# Willoughby City Council Western Harbour Tunnel and Warringah Freeway Upgrade Submission to Transport for NSW

Council has prepared this submission to identify and convey concerns regarding the impact on Council's residents, assets and businesses caused by the Western Harbour Tunnel and Warringah Freeway Upgrade project, as detailed in the TfNSW Reference Documents.

Proposed Change to Sydney Alpha-numeric route numbering System (1-2)

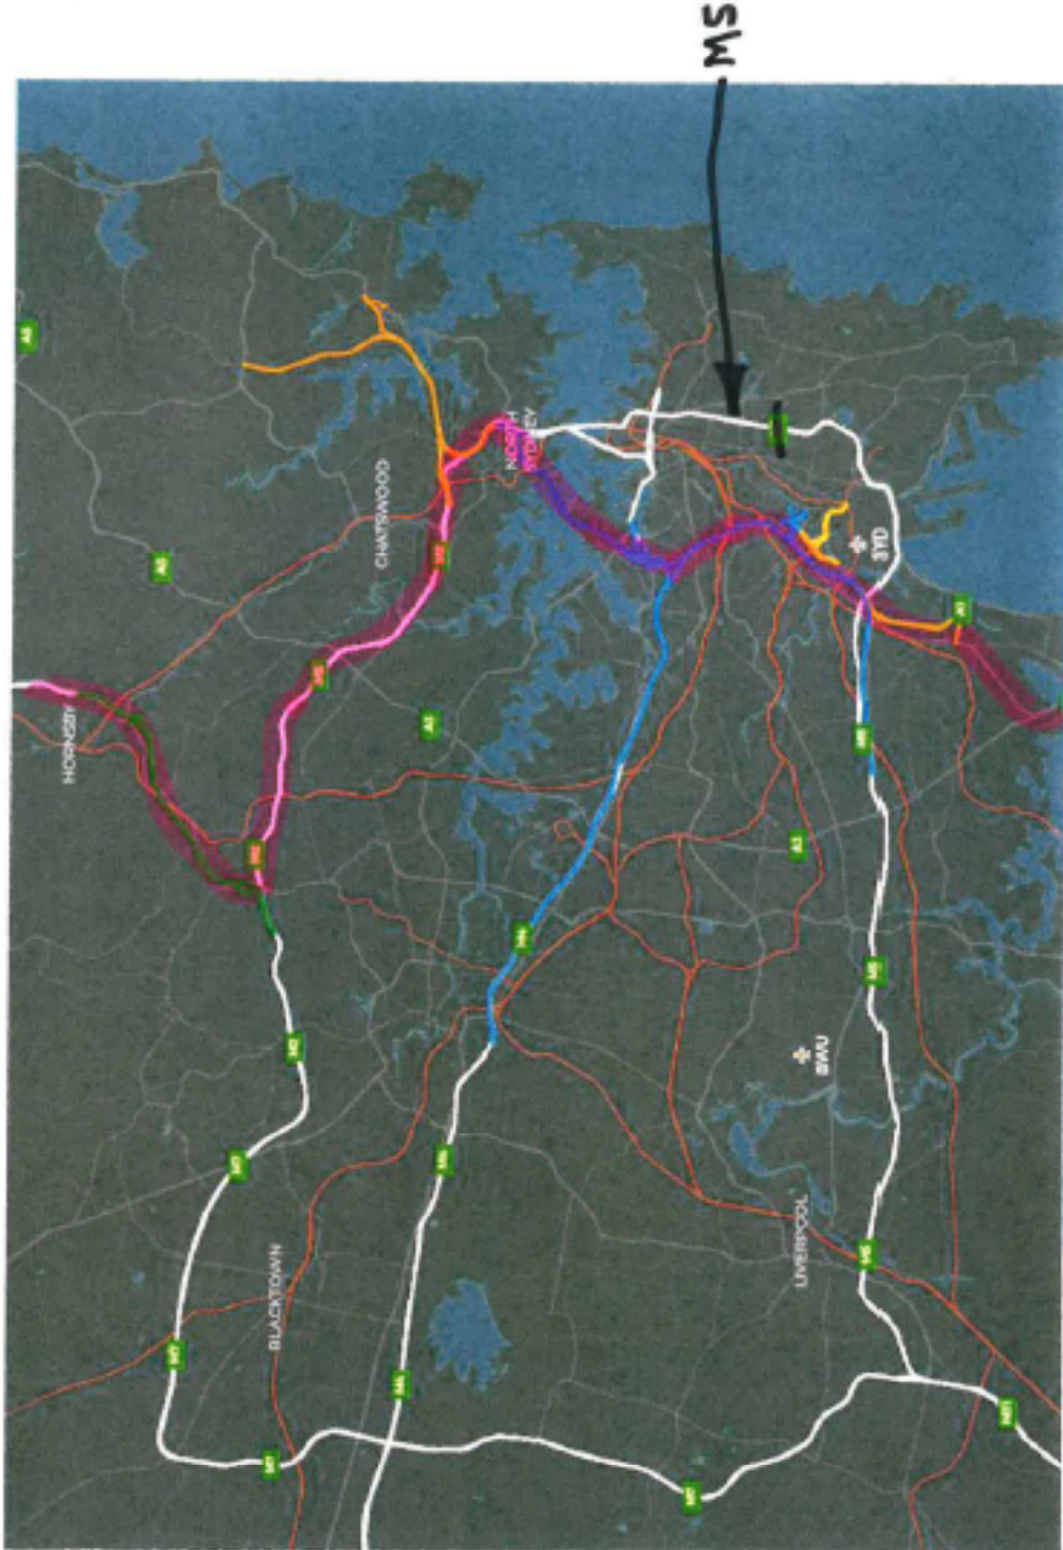
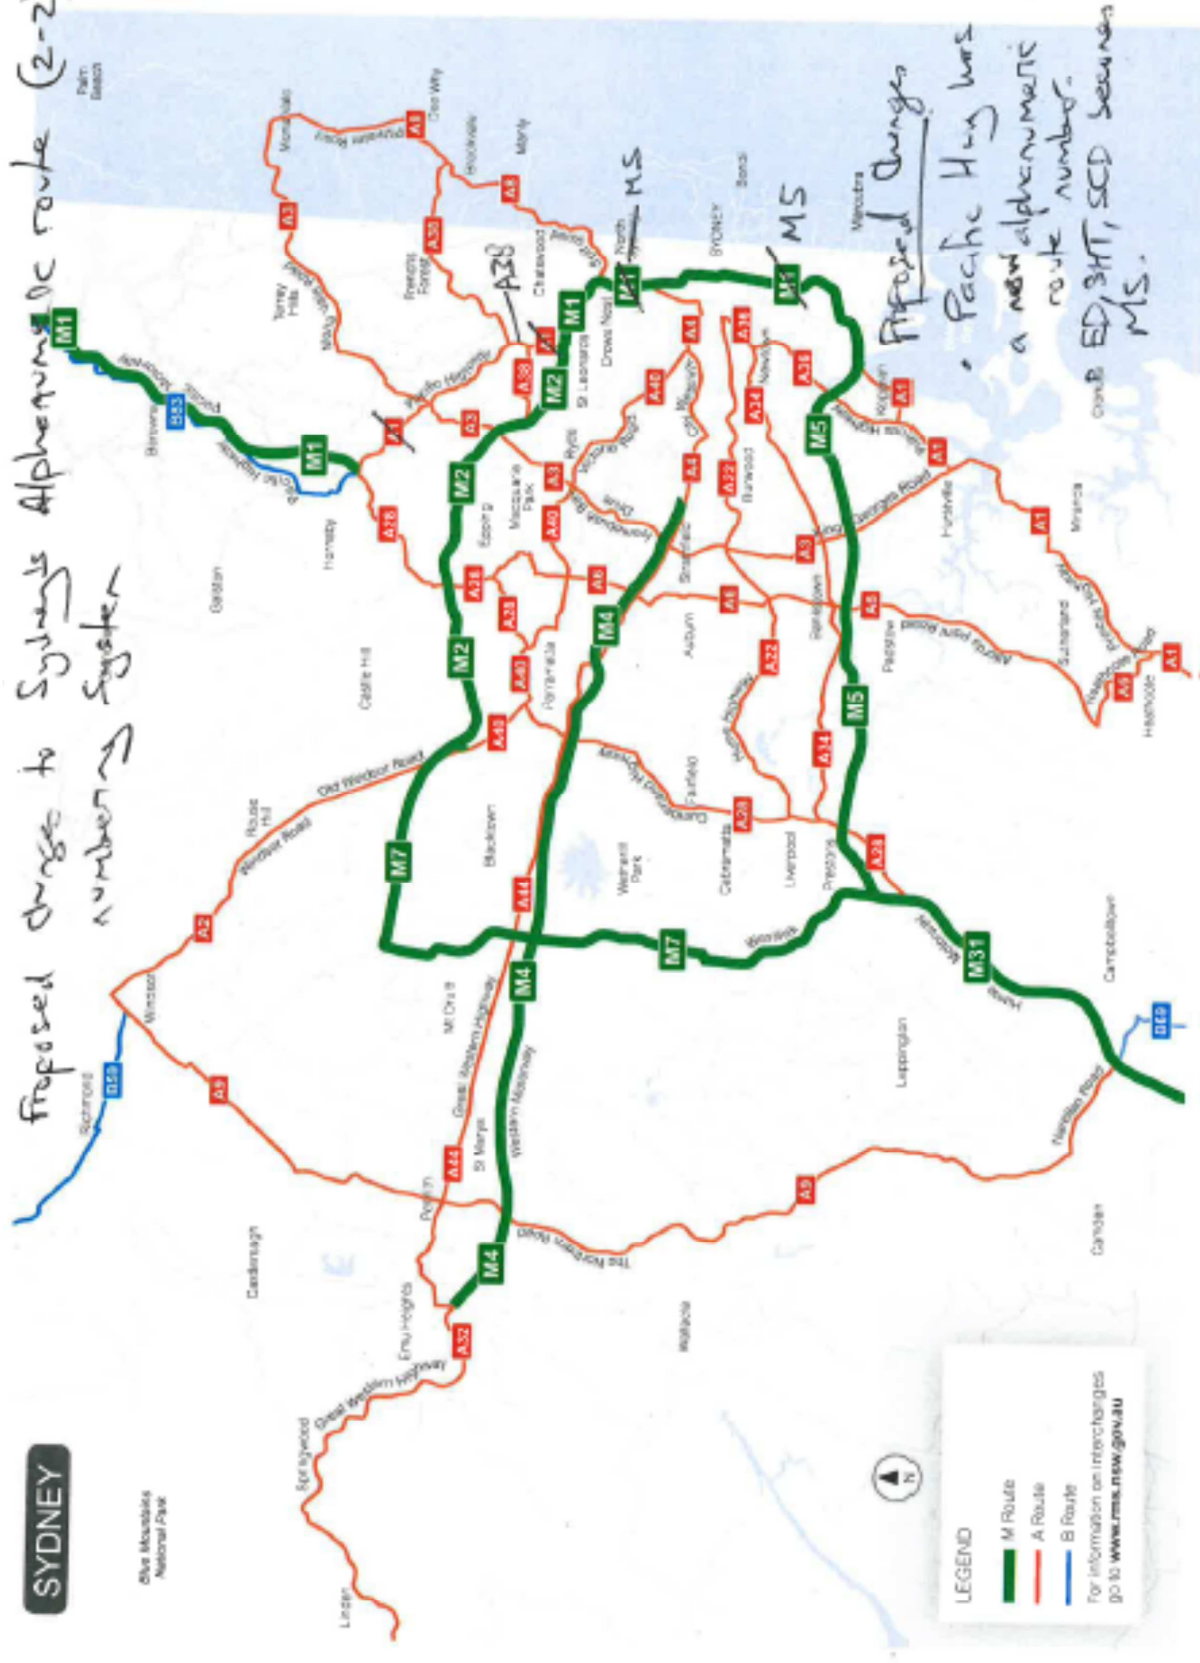
Proposed changes  
 Pacific Hwy has  
 a new alphanumeric  
 route number.  
 could ED, SHT, SCD become  
 M5.

Proposed New Motorway Name for Sydney Harbour Tunnel, Eastern Distributor and Southern Cross Drive

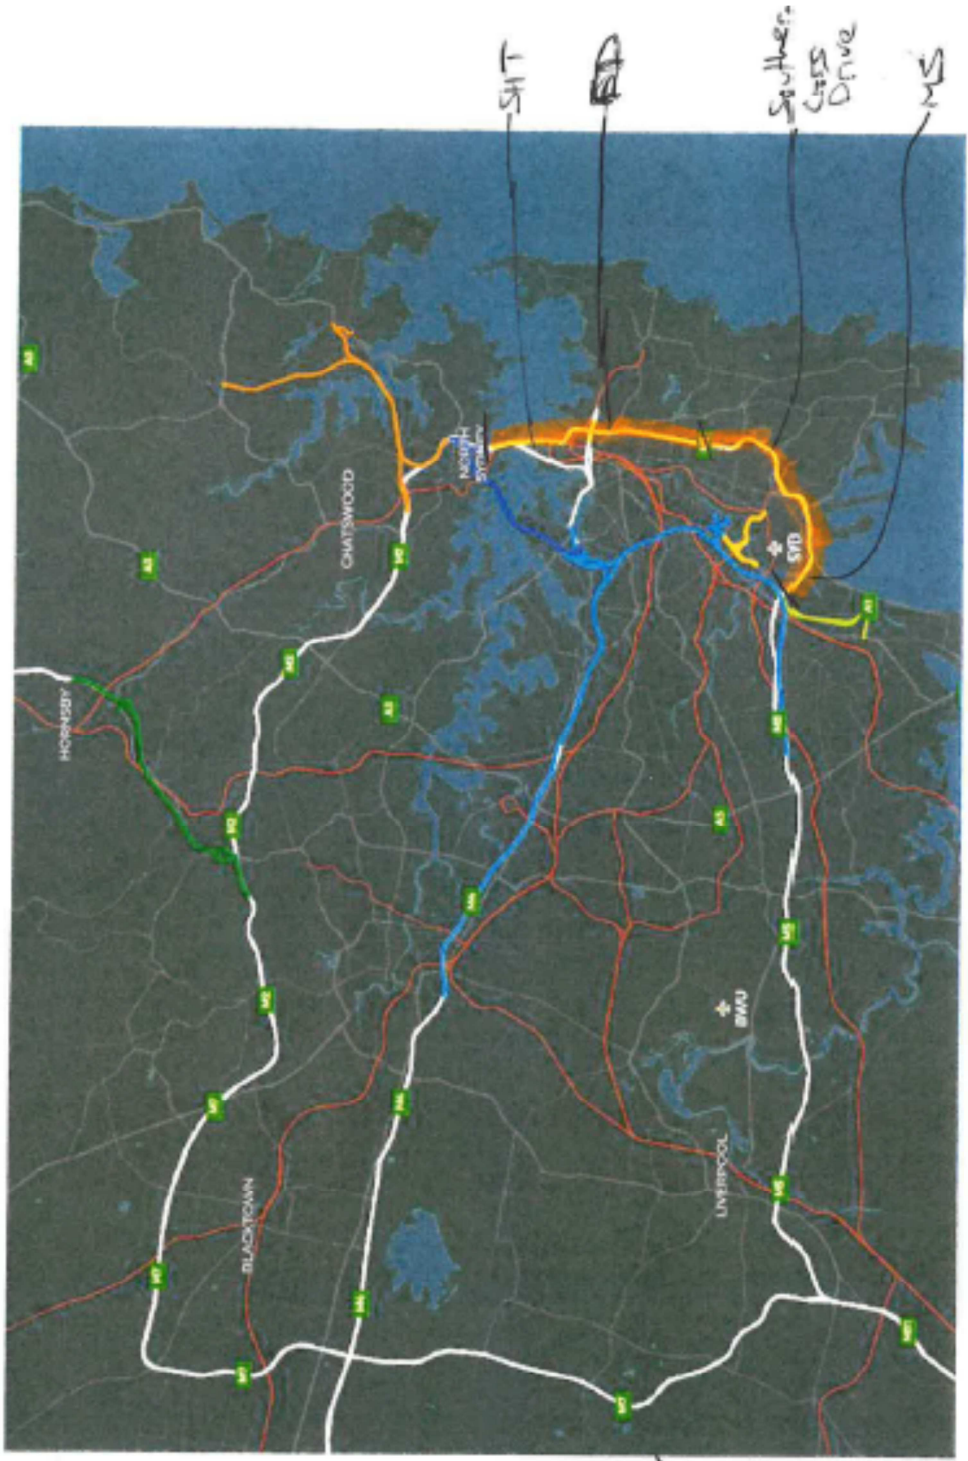
Proposed to introduce a new Motorway Name
